## 11. POWER DISTRIBUTION COMPARISONS

In response to your letter of July 18, 1984, the NRC staff, with the technical assistance of Brookhaven National Laboratory (BNL), is reviewing Duke Power Company topical report DPC-NF-2010 which describes the nuclear physics methodology for reload design at the McGuire and Catawba Nuclear Stations. We find that additional information identified in the enclosure is needed to complete this review.

Subject: McGuire Nuclear Station - Docket No. 50-369/370  
Catawba Nuclear Station - Docket No. 50-413/414  
Response Request for Additional Information Regarding  
Topical Report DPC-NF-2010, "Nuclear Physics Metodology  
for Reload Design"

Figure 1. Burnable Poison Rod Configuration

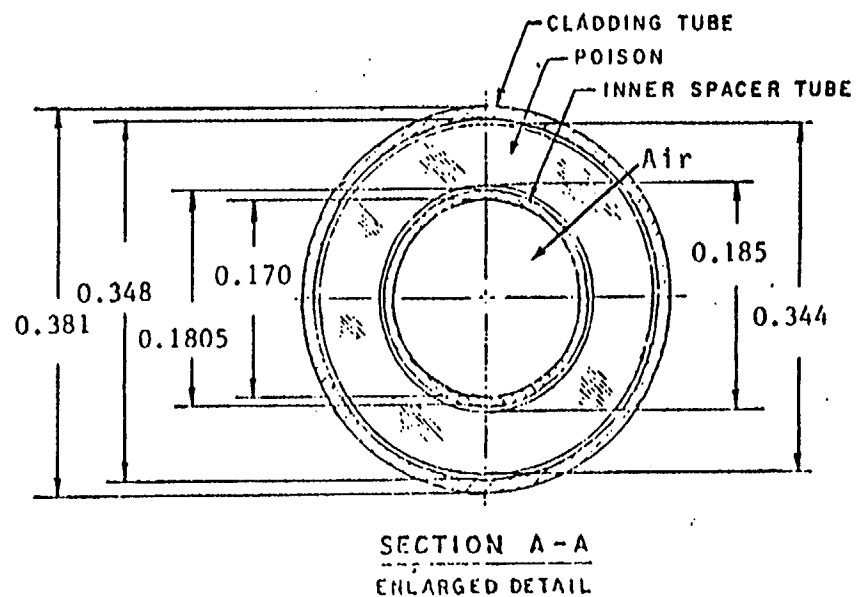
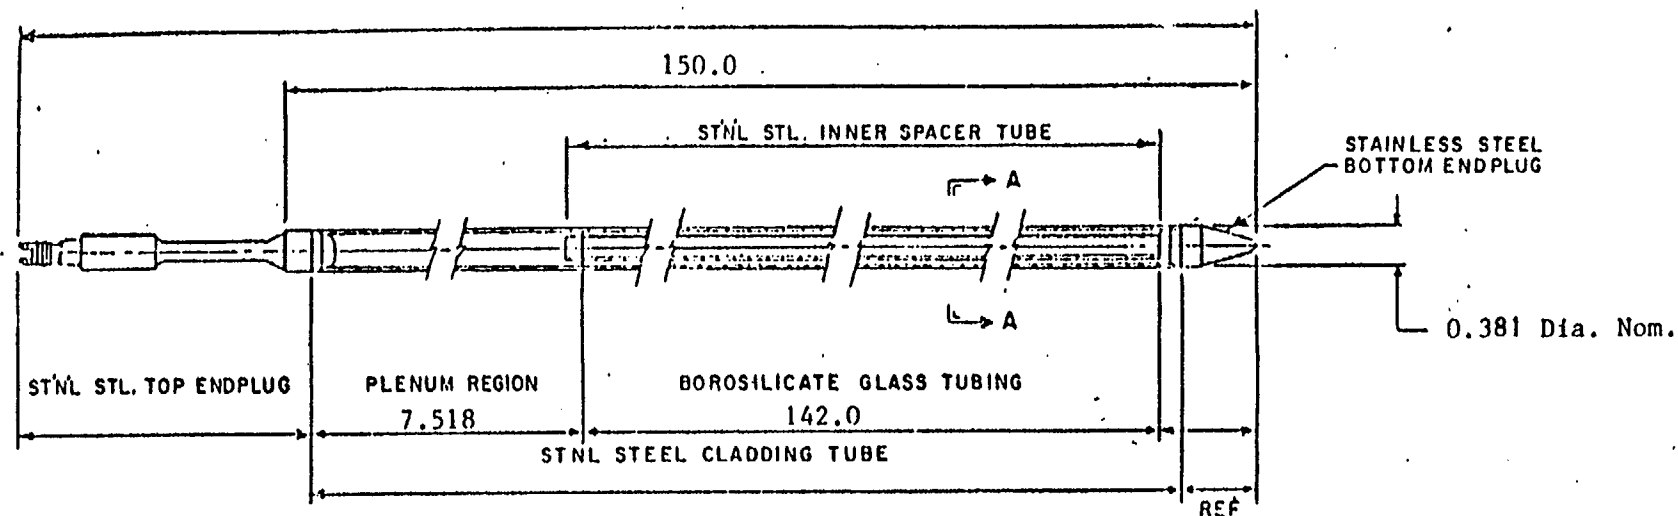
6. Burnable Poison Rod Data (See Figure 1)
